SHEARON HARRIS NUCLEAR POWER PLANT, UNIT NO. 1
DOCKET NO. 50-400 / RENEWED LICENSE NO. NPF-63

Subject: REQUEST FOR LICENSE AMENDMENT
MEASUREMENT UNCERTAINTY RECAPTURE POWER UPRATE
SUPPLEMENTAL INFORMATION

LICENSE AMENDMENT REQUEST
MEASUREMENT UNCERTAINTY RECAPTURE POWER UPRATE
TAC ME6169

HARRIS NUCLEAR PLANT
SUPPLEMENTAL INFORMATION

FIGURE 2.1-1
REACTOR CORE SAFETY LIMITS - THREE LOOPS IN OPERATION
WITH MEASURED RCS FLOW $> [293,540 \text{ GPM} \times (1.0 + C_1)]$

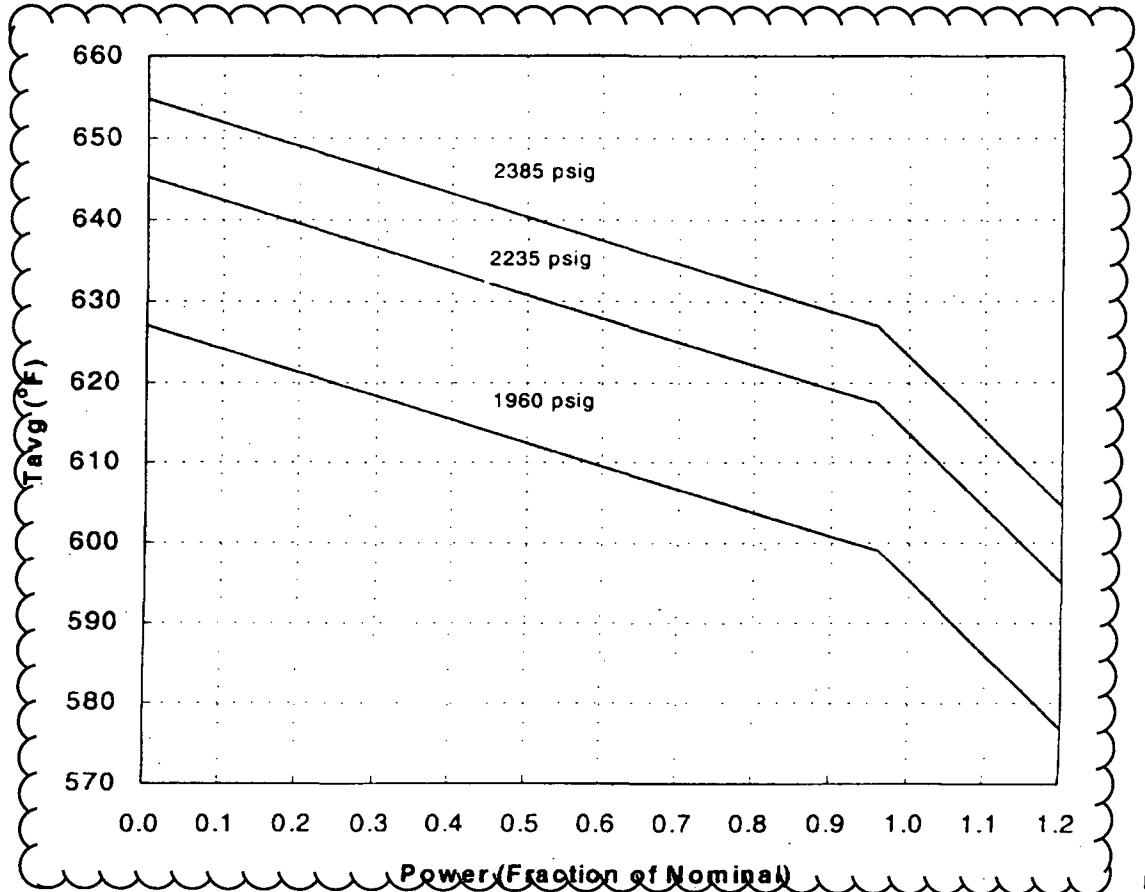
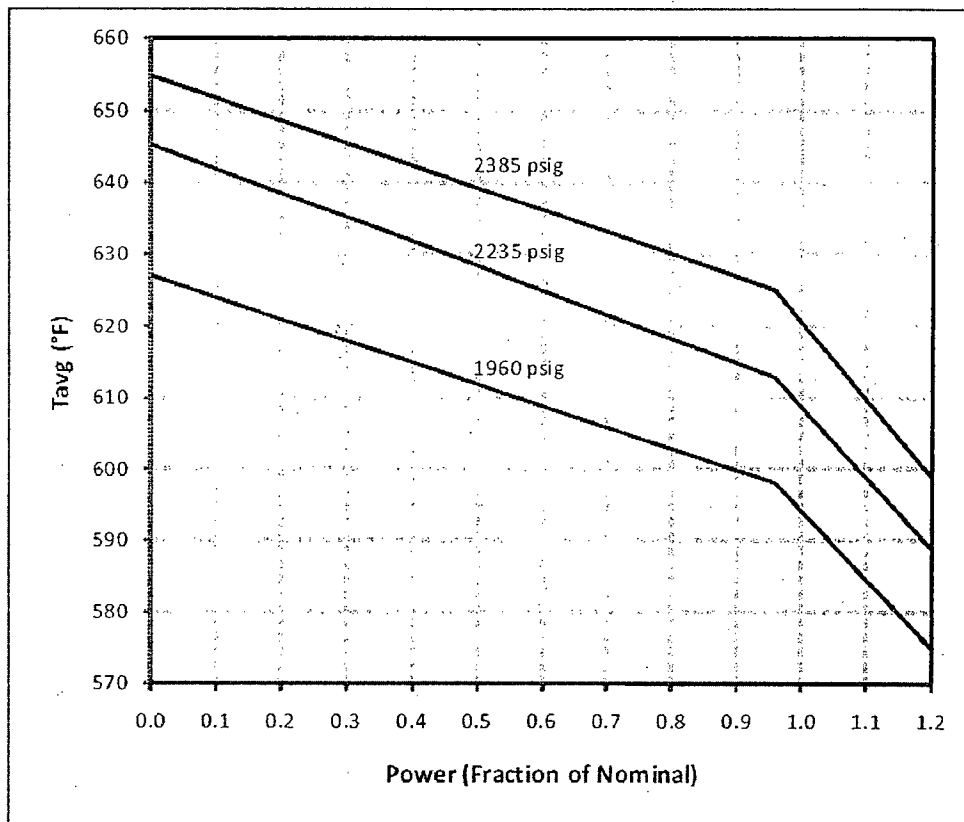
DELETE

Replace with
INSERT A

FIGURE 2.1-1
REACTOR CORE SAFETY LIMITS - THREE LOOPS IN OPERATION
WITH MEASURED RCS FLOW $\geq [293,540 \text{ GPM} \times (1.0 + C_1)]$
